Title: Lost Lake Development Review

To introduce and obtain preliminary feedback from the Minnehaha Creek Watershed District (MCWD) Board of Managers regarding development proposed by Monarch Development Partners at 2400 and 2420 Commerce Boulevard, Mound.

Attachment A – Development Concept Introduction

**2400-2420 Commerce Blvd, Downtown Mound
Development Concept Introduction**

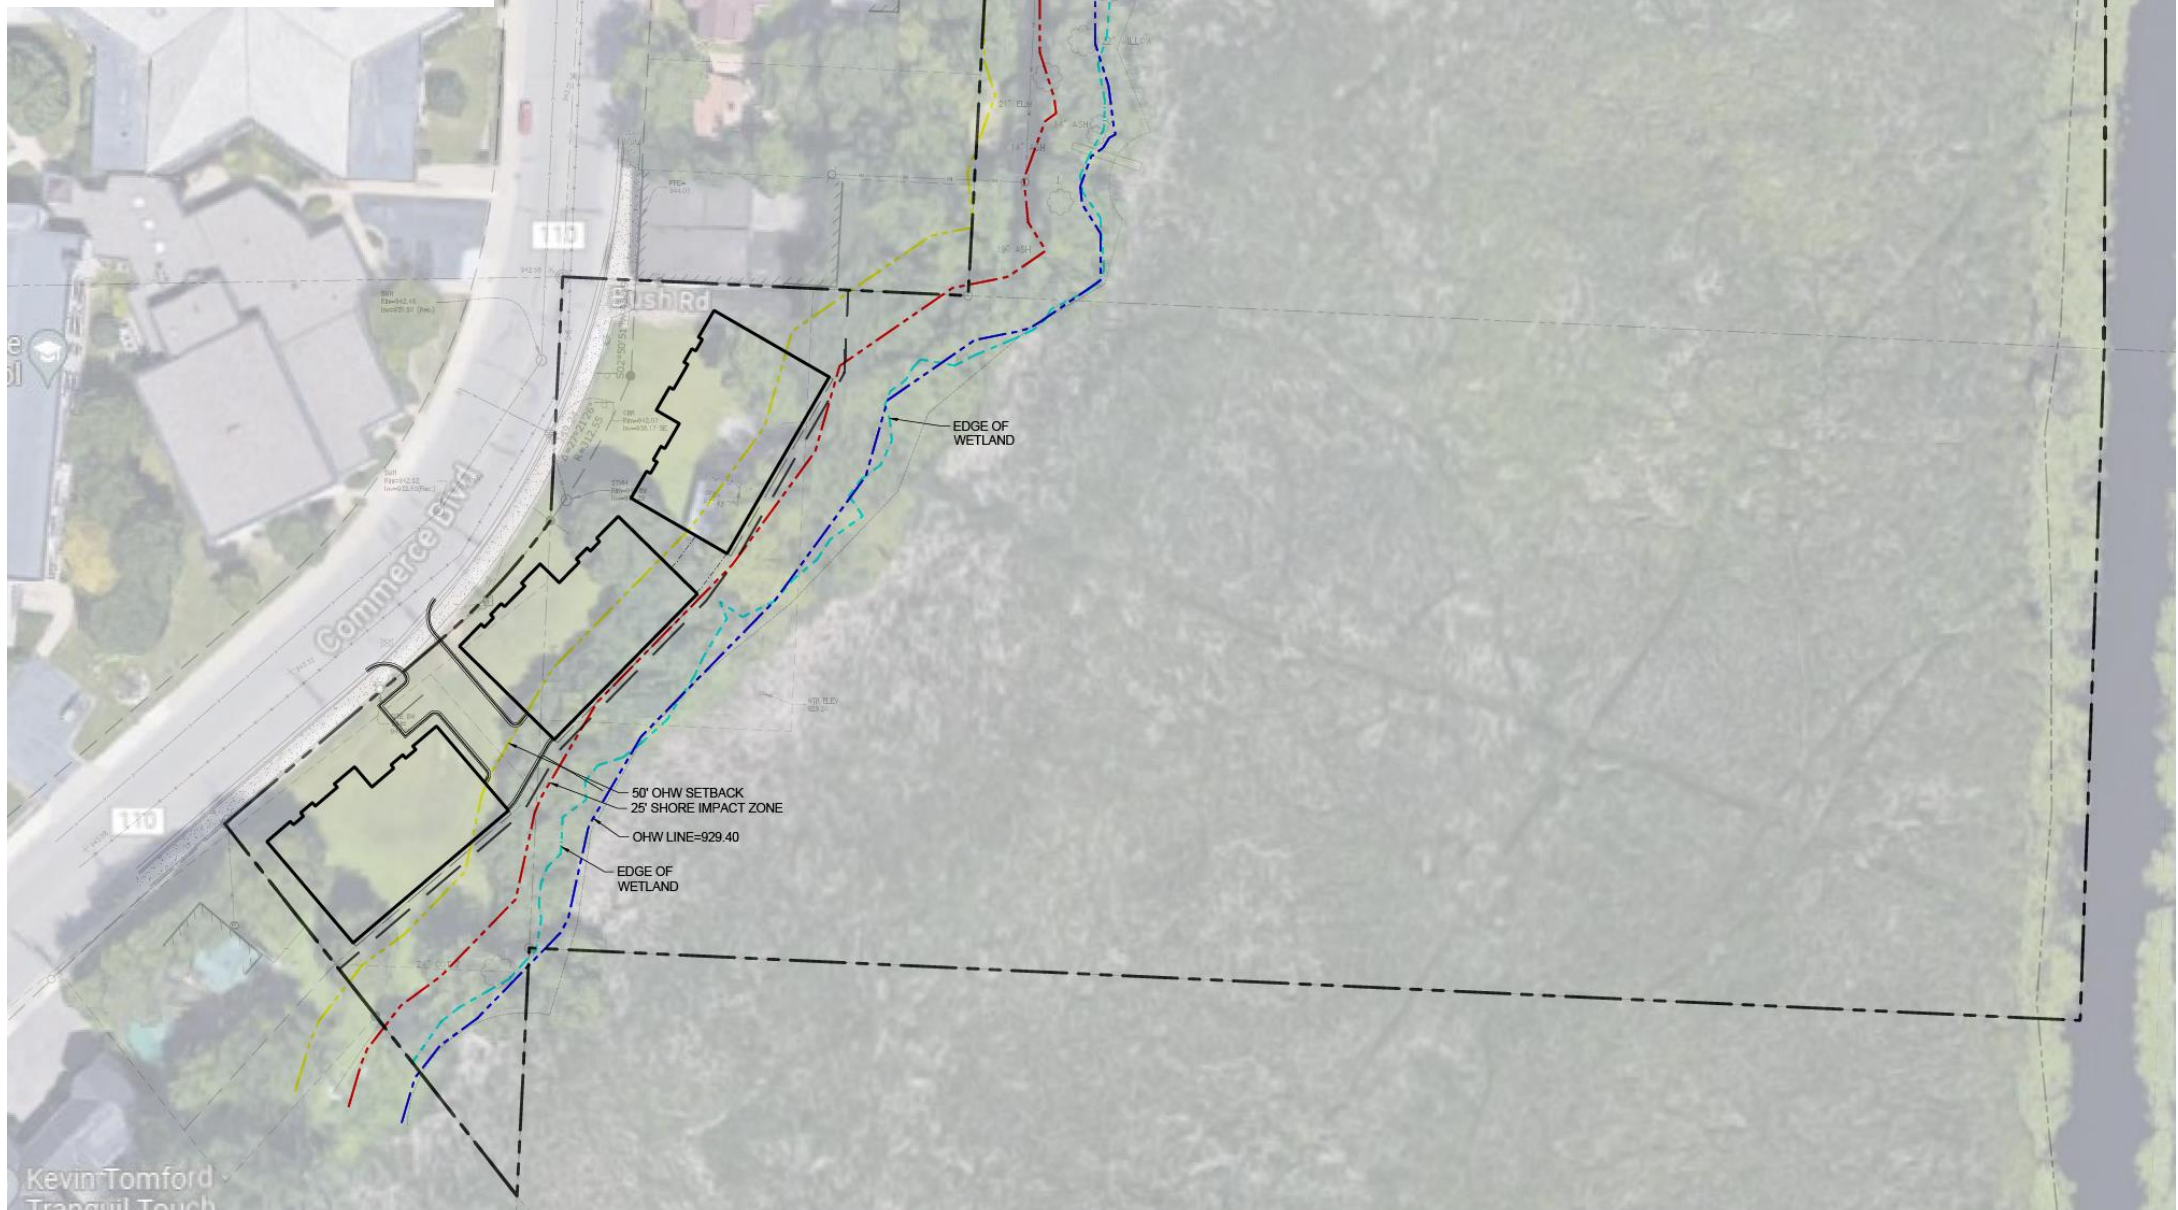
Among the notable revisions to the design, initially proposed external driveways to access parking in the rear of the site, along the west side of Lost Lake, were eliminated. The revised design proposes to incorporate connected driveways and parking underneath the proposed units. This modification increases setbacks from the wetland edge and increases wetland buffer widths and total areas relative to the initial proposal. These changes to the site plan also remove hardcover from within the 25' shoreland impact zone, implemented by the City of Mound. These plan modifications are shown on page 3 of Attachment A and the current proposal in relation to the shoreland impact zone is shown on page 9.

Shoreland Impact Zone at 2400-2420 Commerce Blvd.

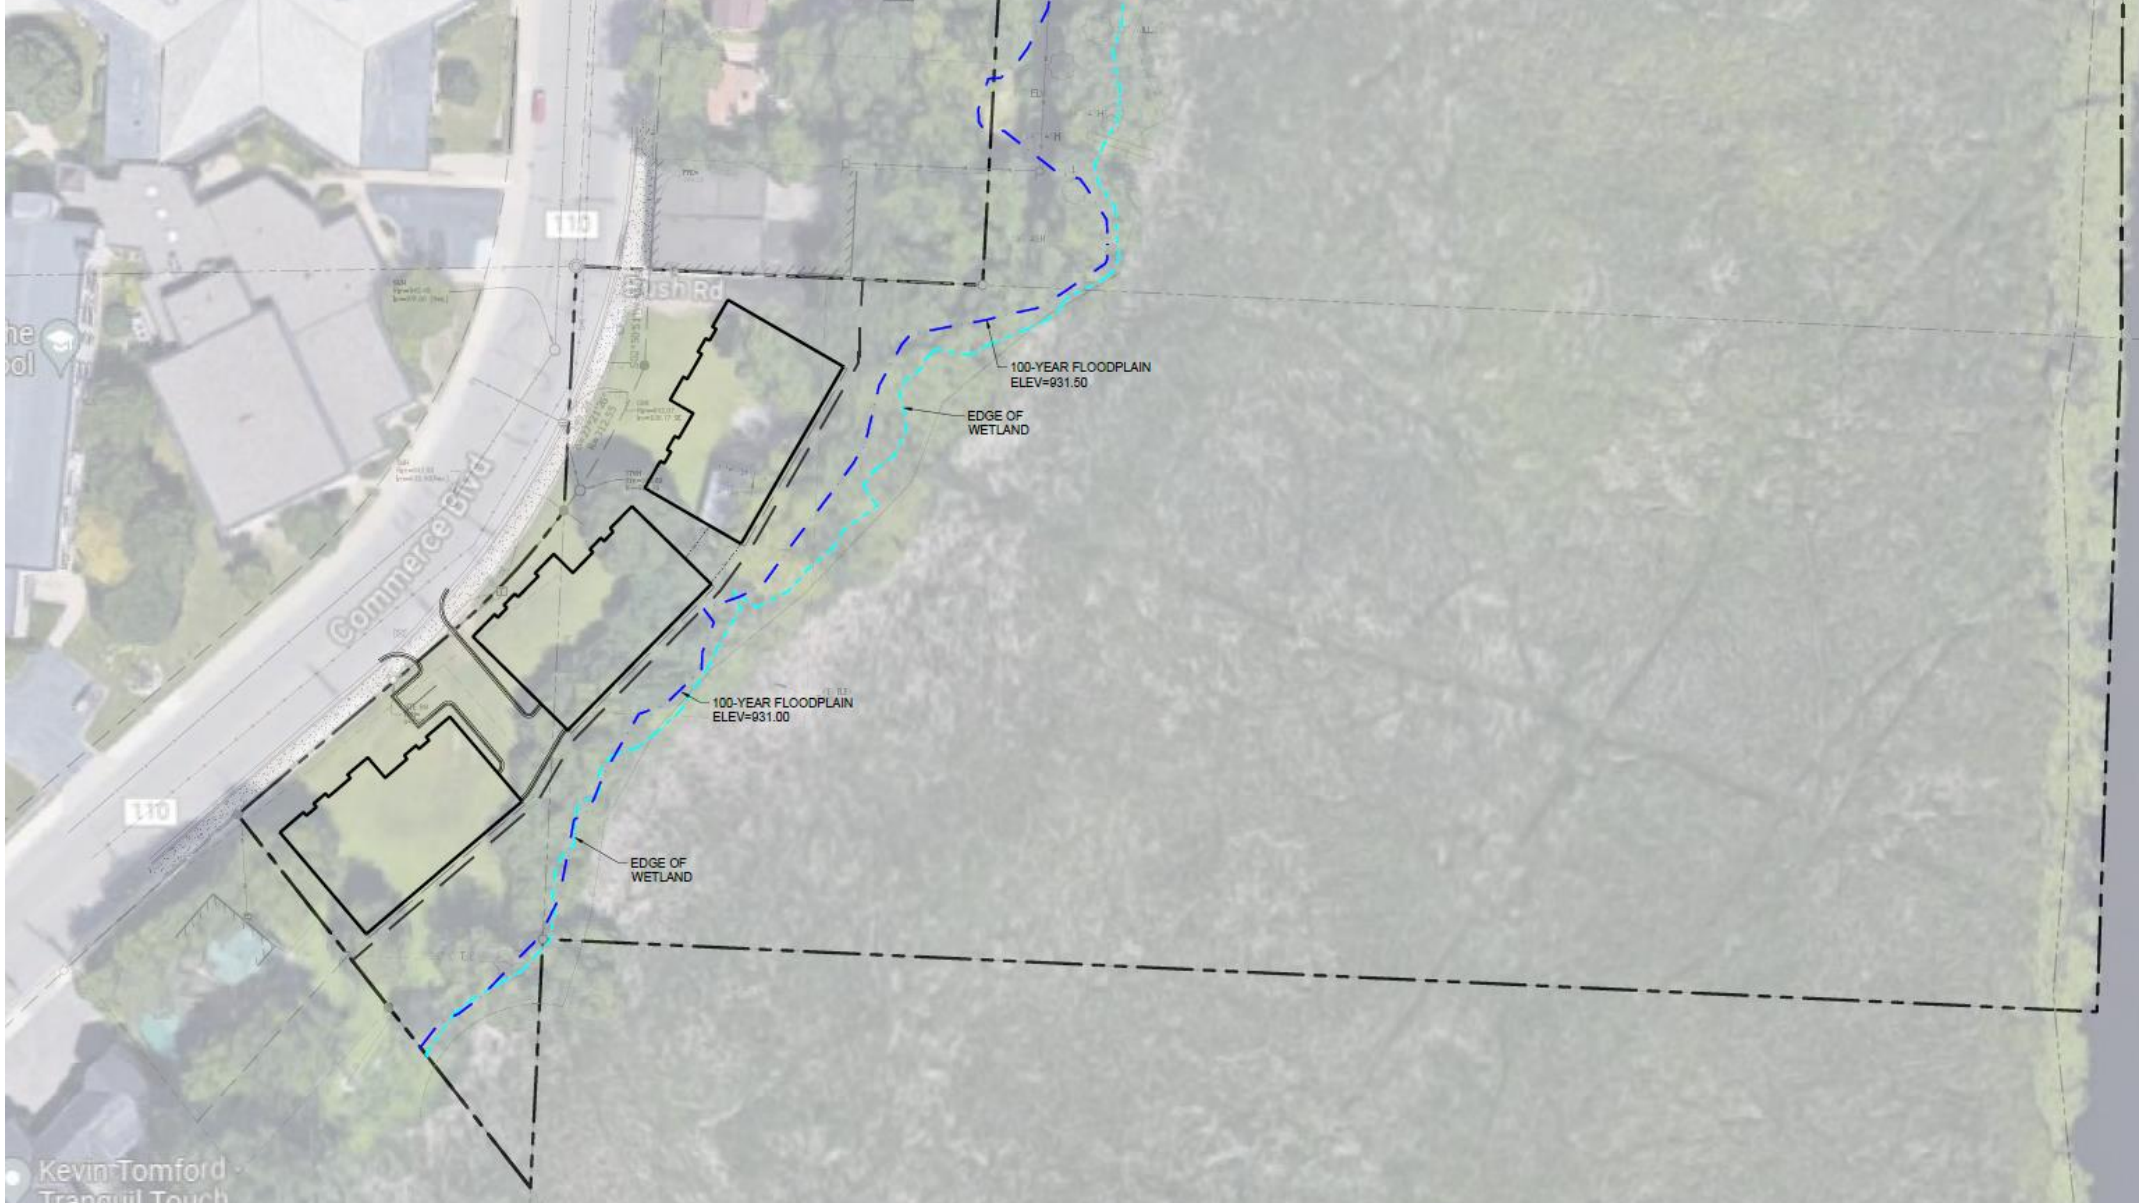
The current development layout has front setbacks from the sidewalk along Commerce Boulevard as narrow as 12.4', with other larger front setbacks constrained by adjacent property boundaries and geometry along the road. Given the site depth, even with relatively narrow front setbacks, and an evolution in the development program that has eliminated rear parking in favor of internal parking under the residential structure, the site is challenged to meet wetland buffer setbacks from Lost Lake to the east.

**75' Wetland Buffer
at 2400-2420 Commerce Blvd.**

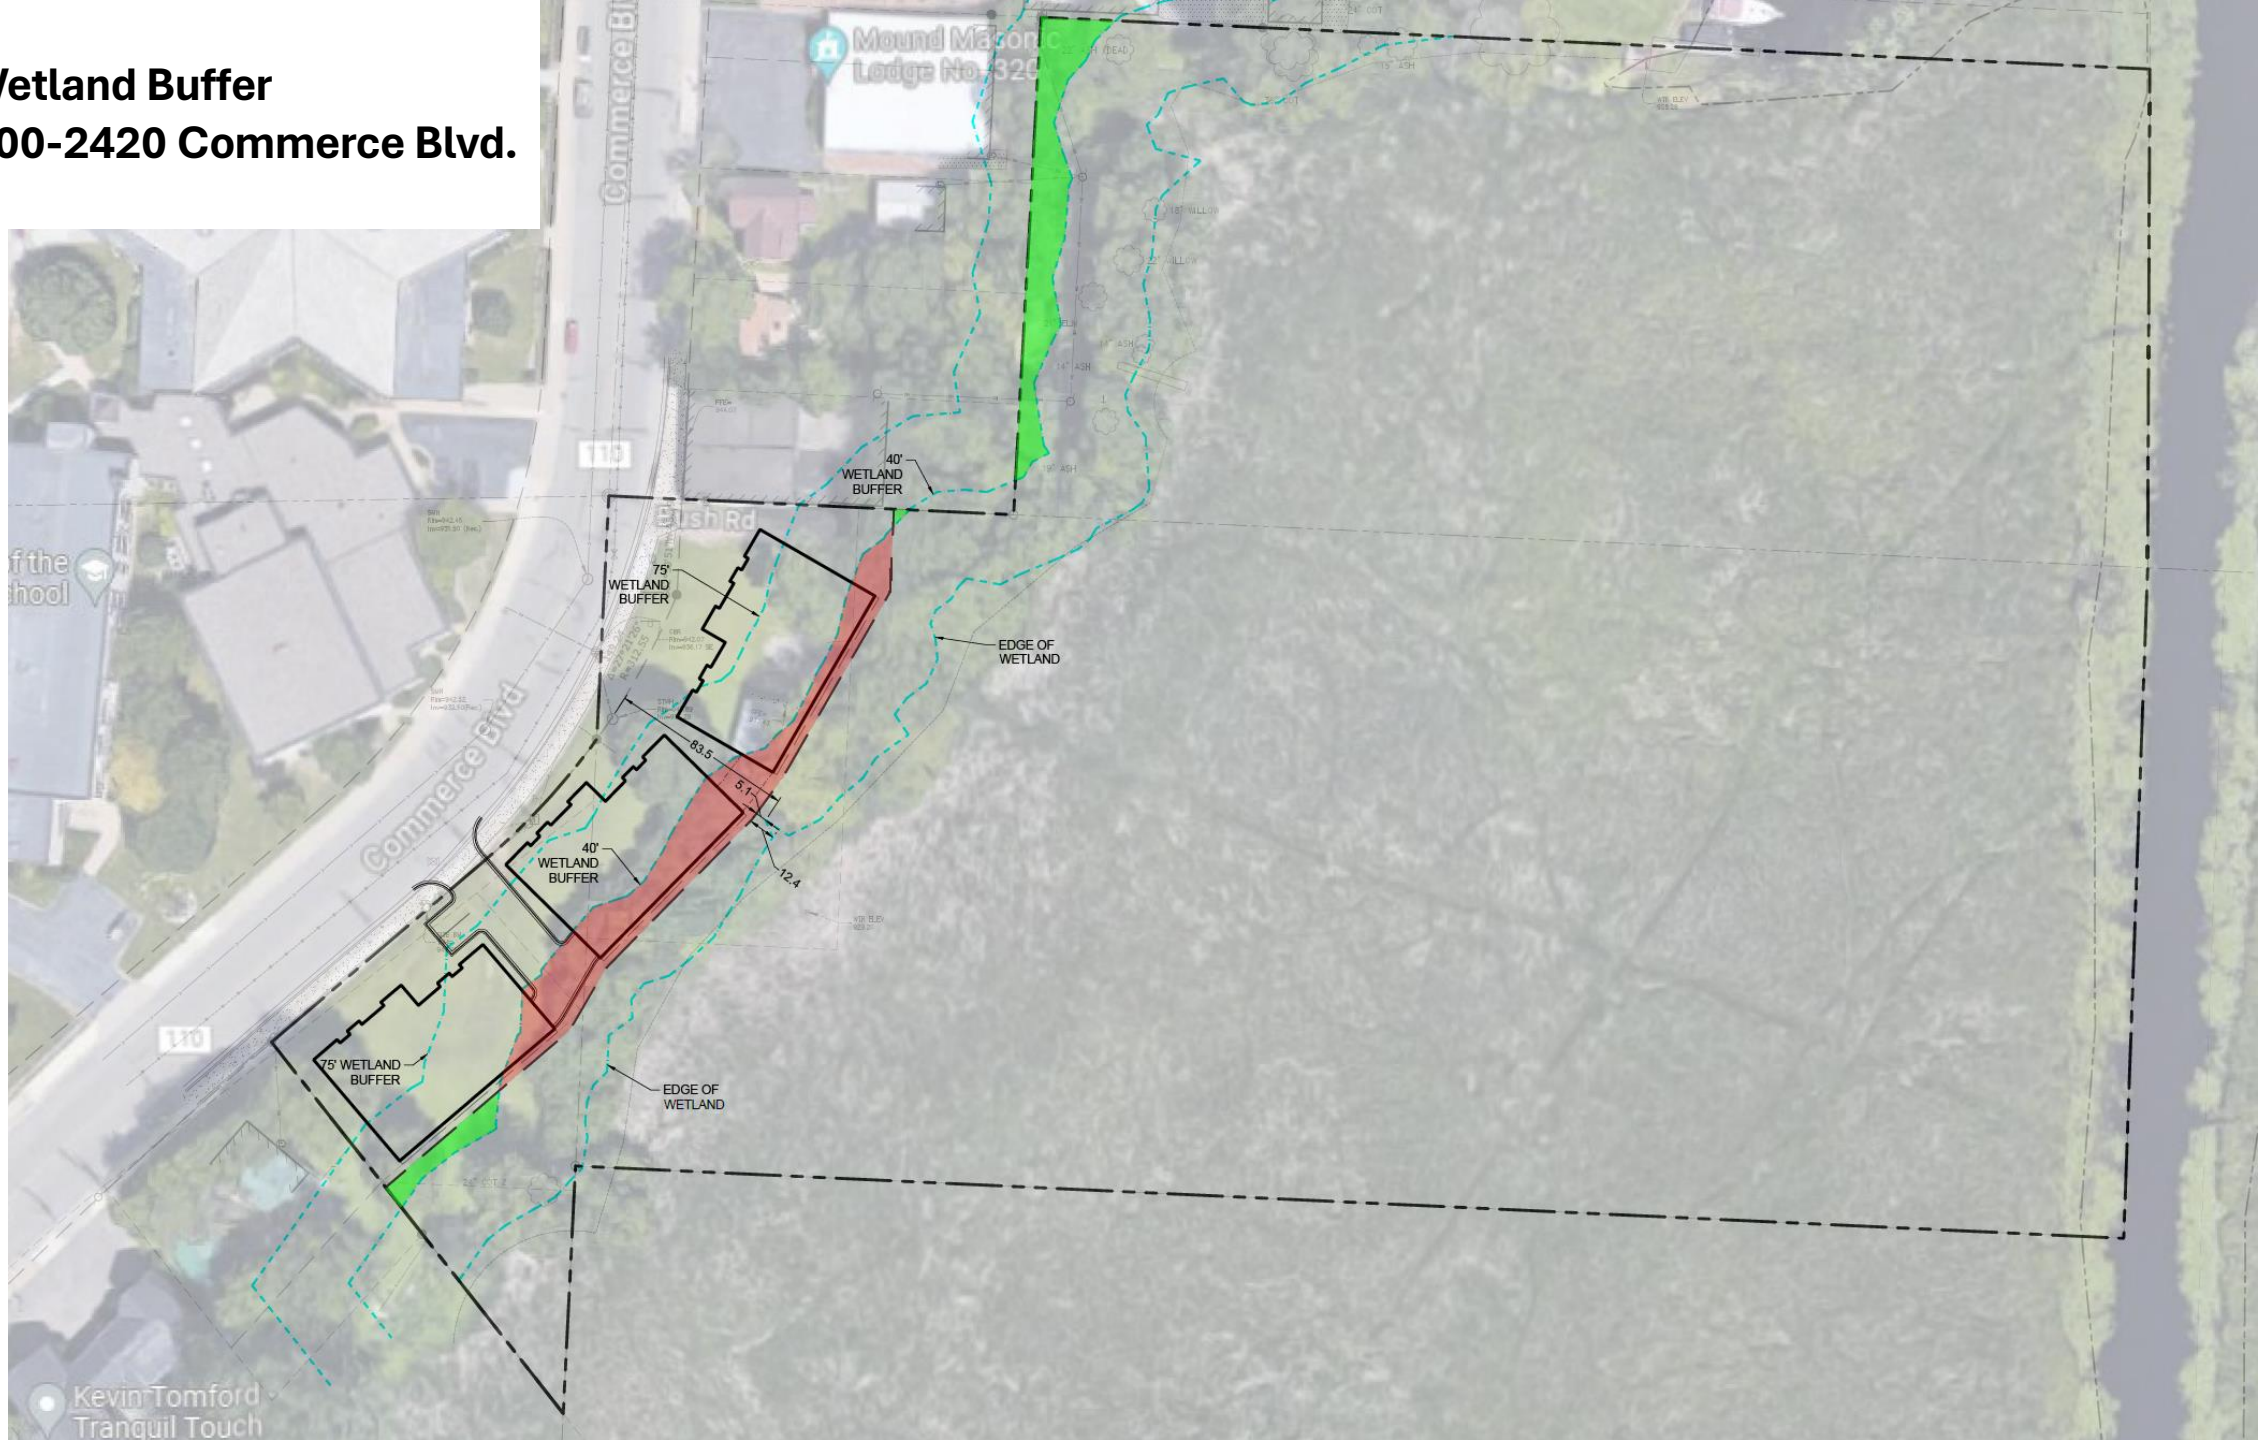
The Project triggers section 4(a)(1) of the Wetland Protection rule. This section states that if an activity requires a permit under the Stormwater Management Rule, a permanent vegetated buffer is required on the part of a wetland that is downgradient of the new or reconstructed impervious surface. Lost Lake is classified as a Preserve wetland and so requires a 75-foot buffer. The current proposal does not meet this rule, as outlined in the Constraints Section below.

Lost Lake is identified by MCWD's Functional Assessment of Wetlands (FAW) as a Preserve Wetland, requiring a 75-foot buffer. Monarch Development Partners has been working with Kjolhaug Environmental Services, which has raised the potential to adjust the management classification from Preserve to Manage 1. This would reduce the required wetland buffer width to 40 feet, which would apply to all future wetland buffers that the District wetland rule would impose around Lost Lake. MCWD reviews any proposed wetland classification change under the Minnesota Routine Assessment Method (MnRAM), and with affiliated data, and would require detailed case-specific technical analysis that demonstrates that the proposed reclassification is due to unique characteristics of this site. Pages 11 and 12 of Attachment A contains site plans with the 75' and 40' buffers overlaid. In either case, the proposal would not meet the District's buffer requirement.

Under either a Preserve or a Manage 1 wetland classification, the currently proposed Project would require a Variance or Exception from the Wetland Protection Rule. This is due to the current site layout having multiple locations where the minimum buffer width is not met and the site being unable to achieve the required buffer area.
